ANNAPOLIS-2019-A

SITE: WHITETAIL RIDGE PH.3

CIVIC ADDRESS: 343 ANTLER COURT

Plans Review
Municipality of
Mississippi Mills
Building Dept.
2022-09-26

ROOF PLAN-A NTS

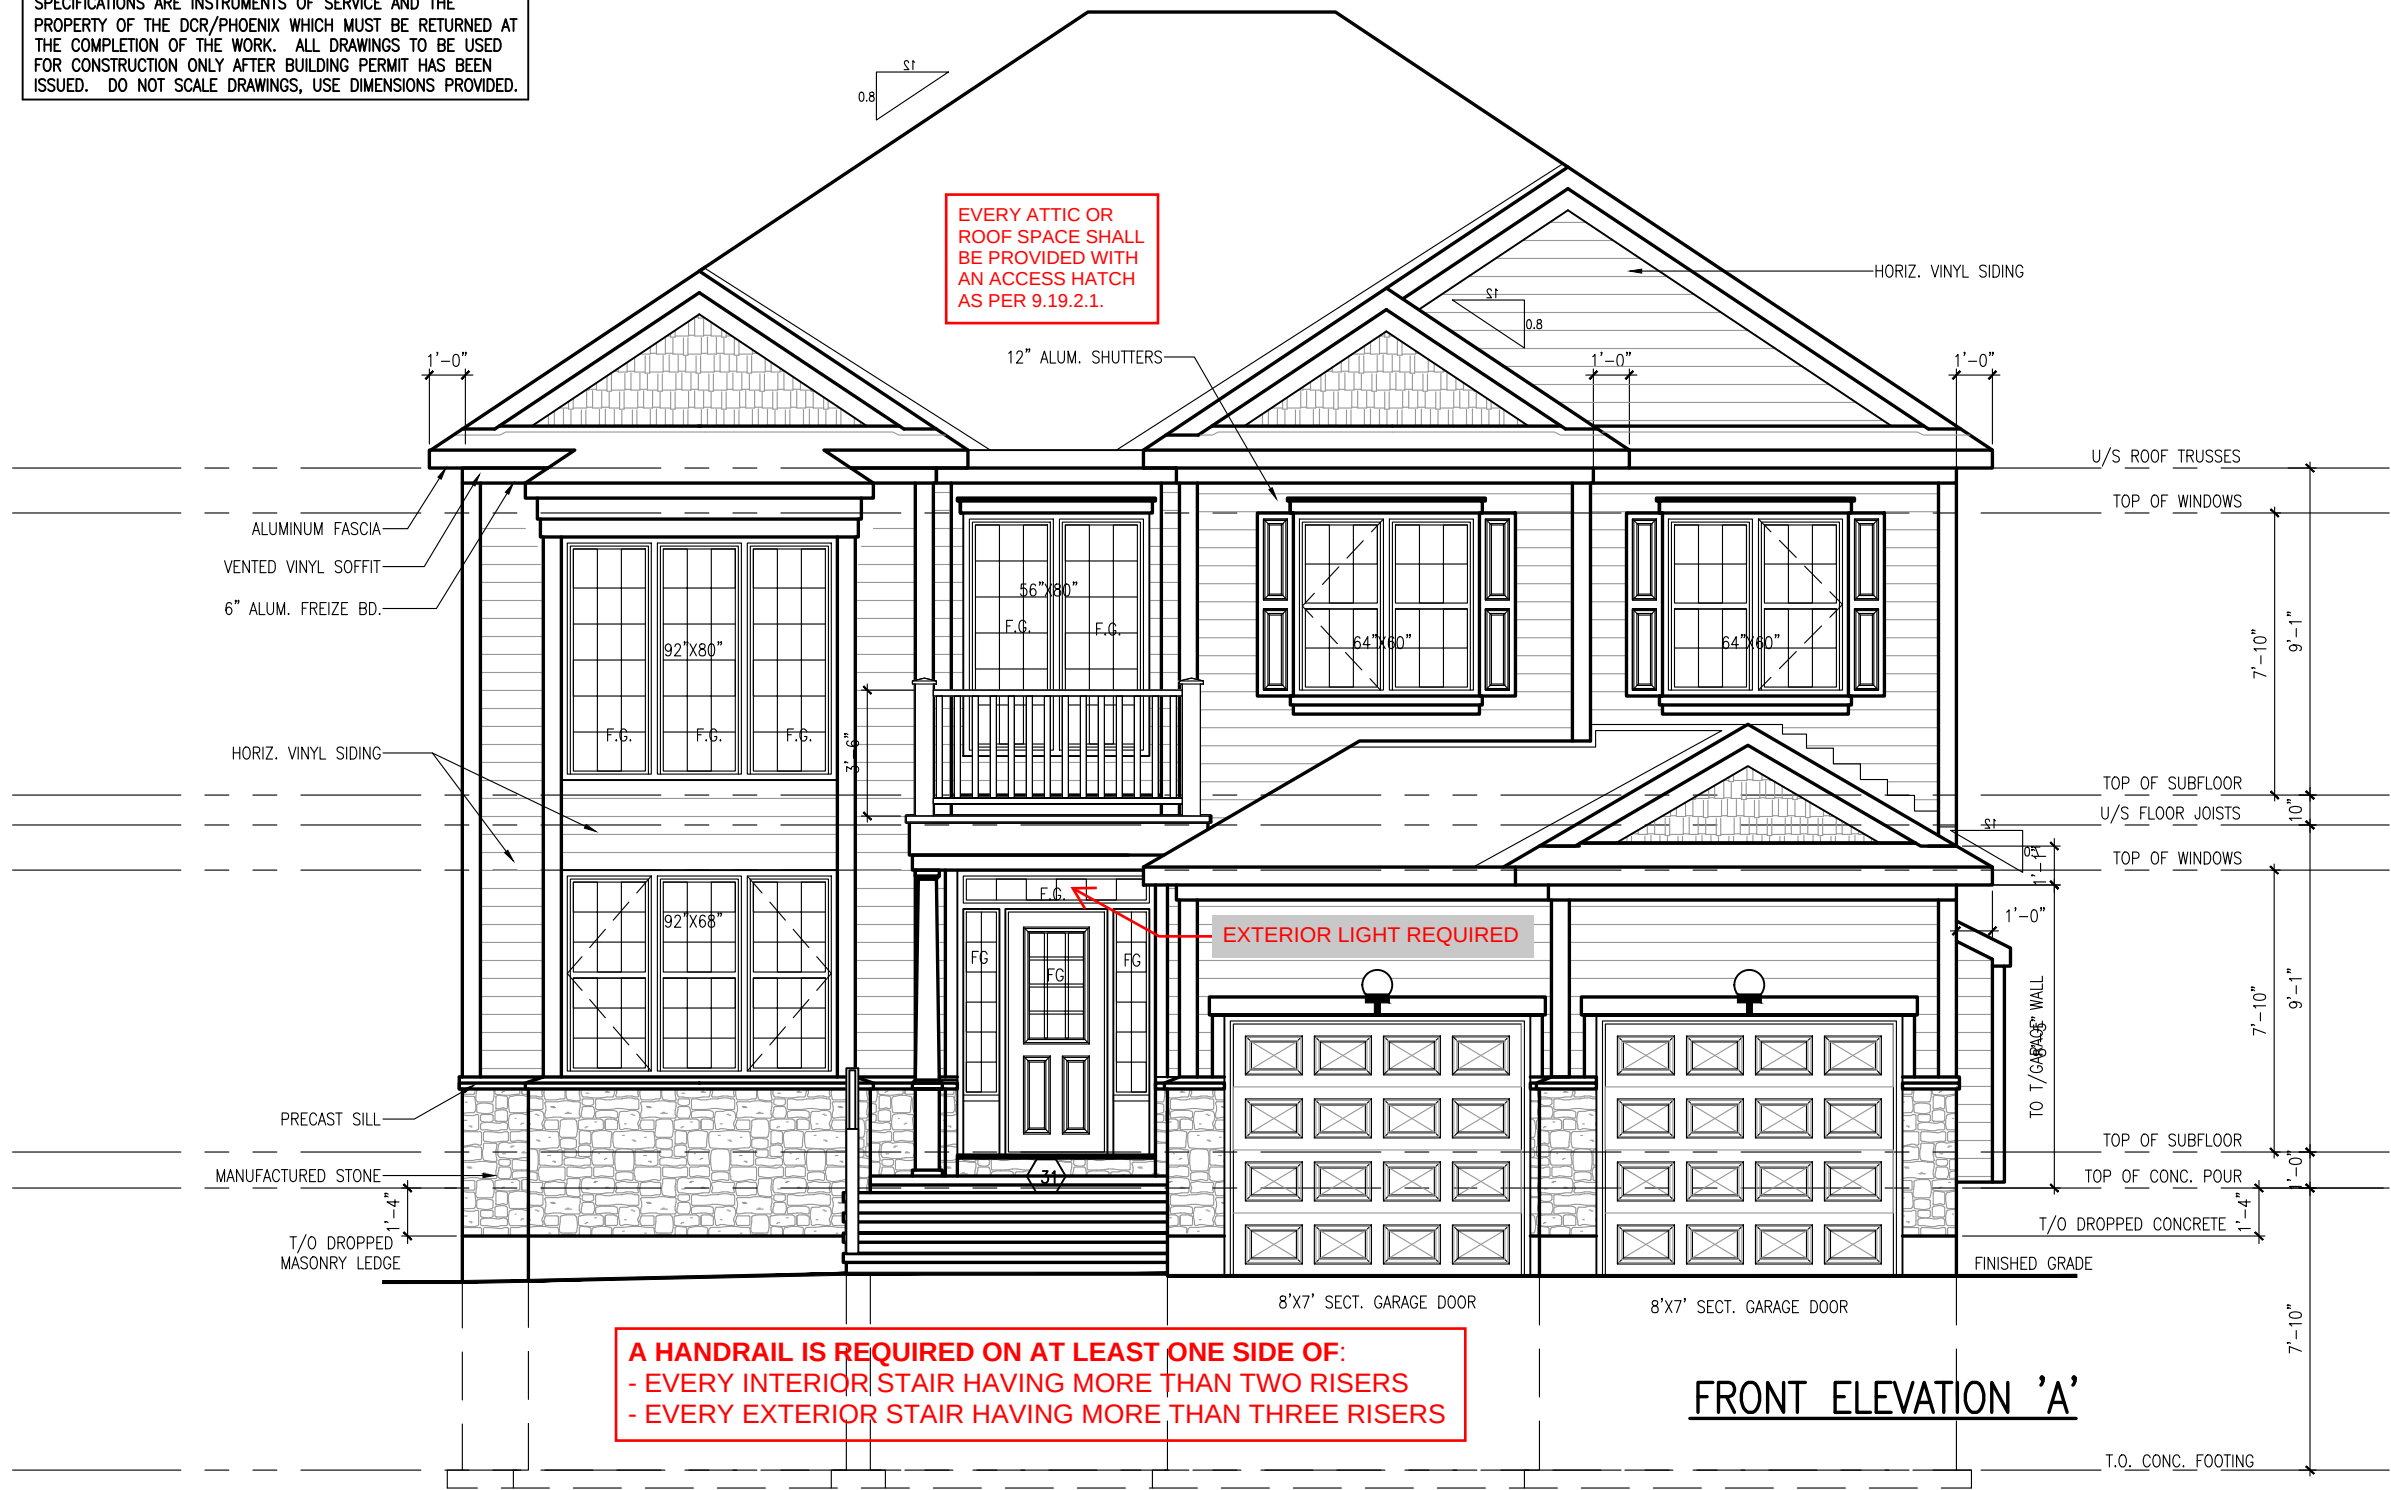
1/300 ROOF VENTILATION REQUIRED

LEFT SIDE ELEVATION 'A'

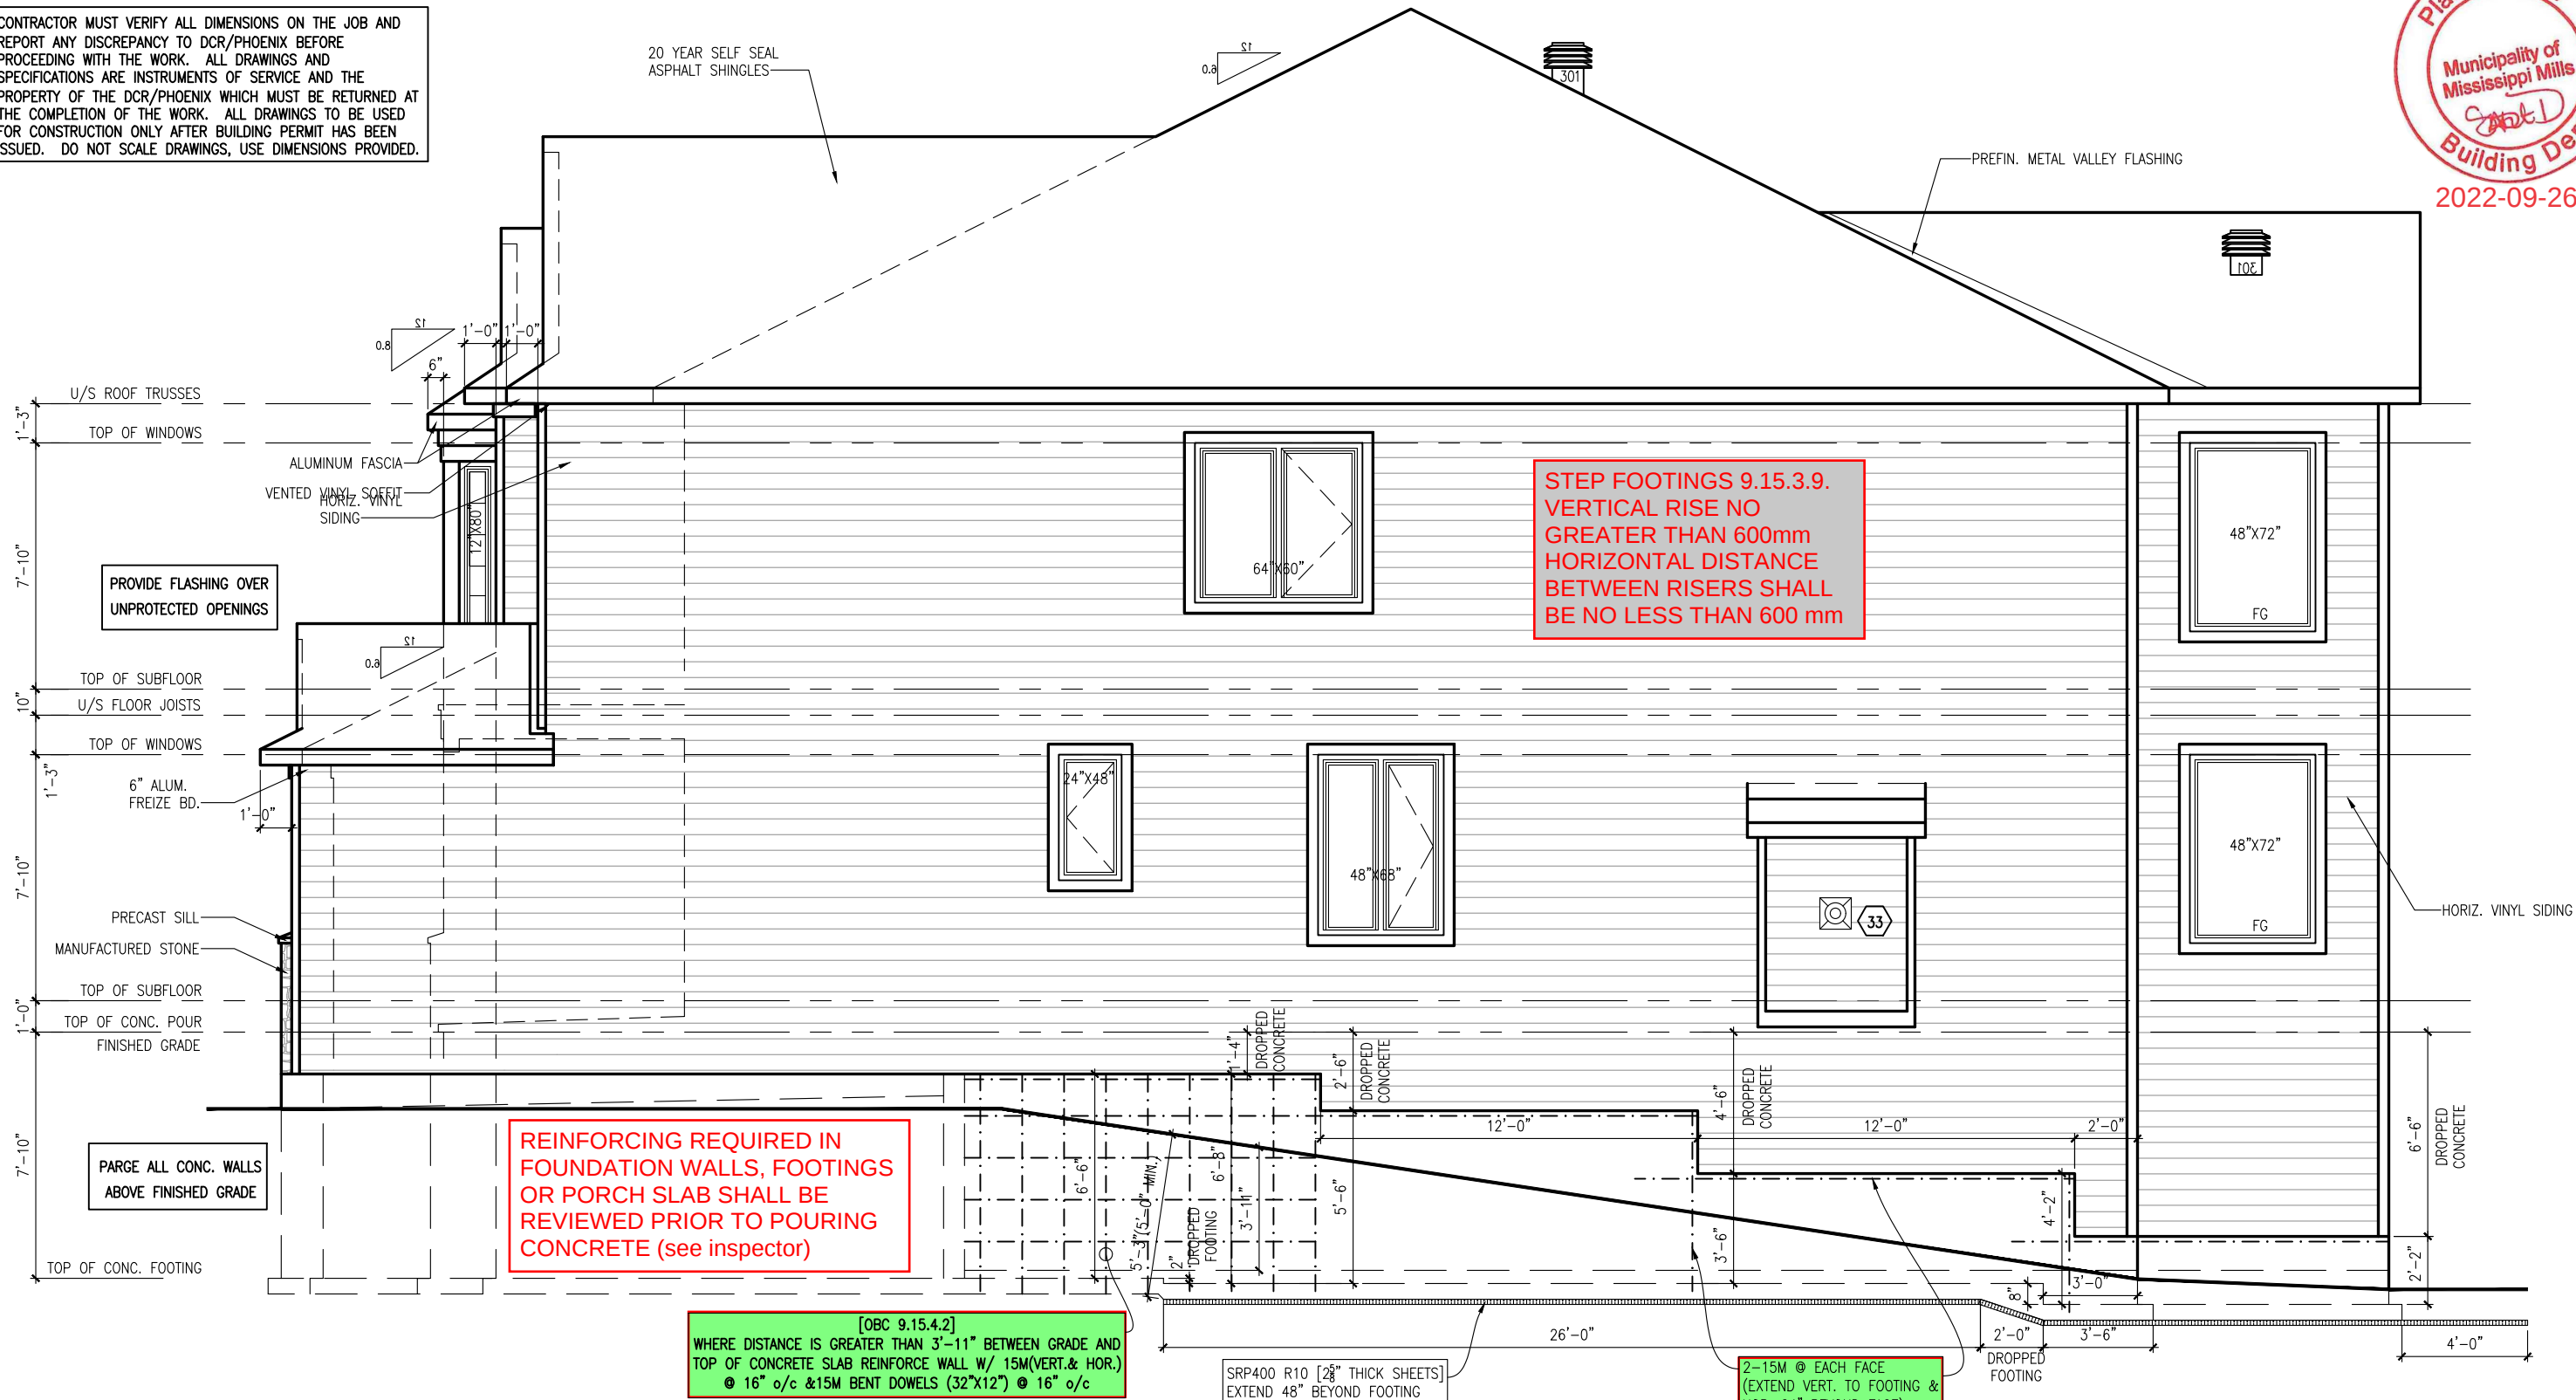
STEP FOOTINGS 9.15.3.9.
VERTICAL RISE NO
GREATER THAN 600mm
HORIZONTAL DISTANCE
BETWEEN RISERS SHALL BE
NO LESS THAN 600 mm

REINFORCING REQUIRED IN FOUNDATION WALLS,
FOOTINGS OR PORCH SLAB SHALL BE REVIEWED
PRIOR TO POURING CONCRETE (see inspector)

A HANDRAIL IS REQUIRED ON
AT LEAST ONE SIDE OF EVERY
EXTERIOR STAIR HAVING
MORE THAN THREE RISERS

SRP400 R10 [28" THICK SHEETS]
EXTEND 48" BEYOND FOOTING

2-15M @ EACH FACE
(EXTEND VERT. TO FOOTING &
HOR. 24" BEYOND FACE)

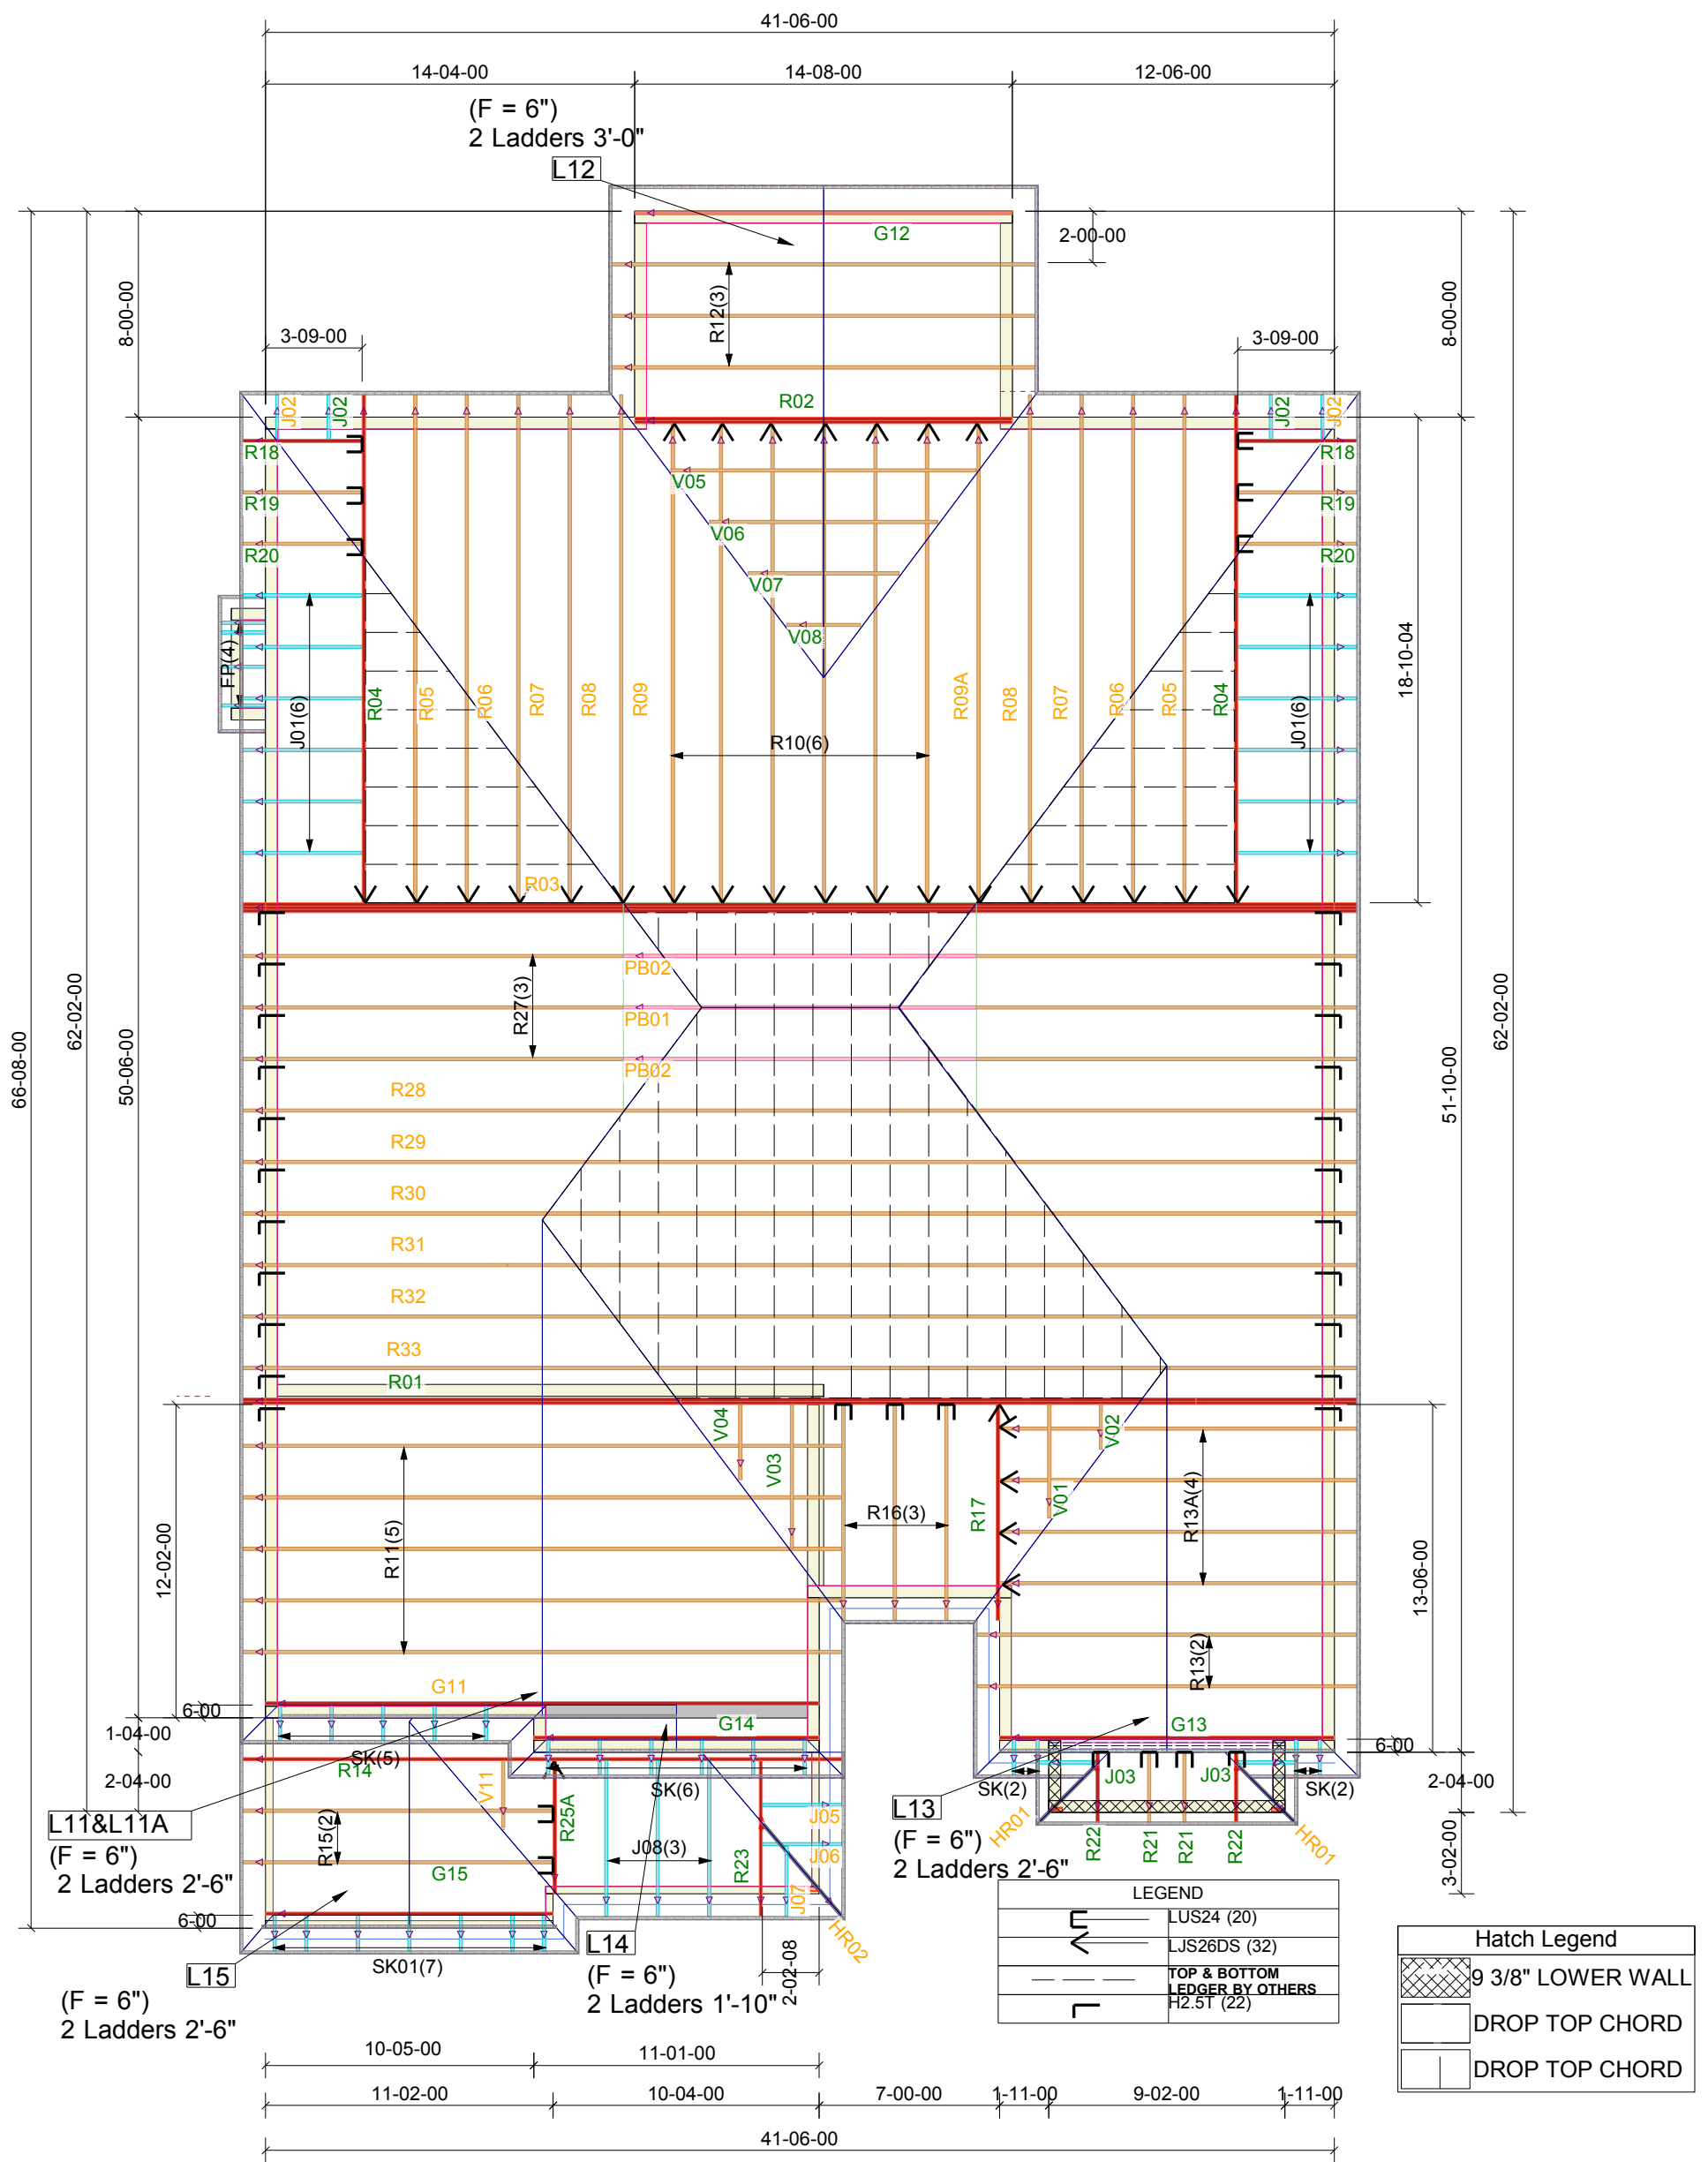
DETAILS SEALED BY A P.ENG ARE REQUIRED FOR THE LVL BEAMS ON FRAMING INSPECTION

PROVIDE P.ENG APPROVED FLOOR DRAWINGS AND SPECIFICATIONS TO BUILDING INSPECTOR AT FRAMING INSPECTION

PROVIDE P.ENG APPROVED TRUSS
DRAWINGS AND SPECIFICATIONS
TO BUILDING INSPECTOR AT
FRAMING INSPECTION
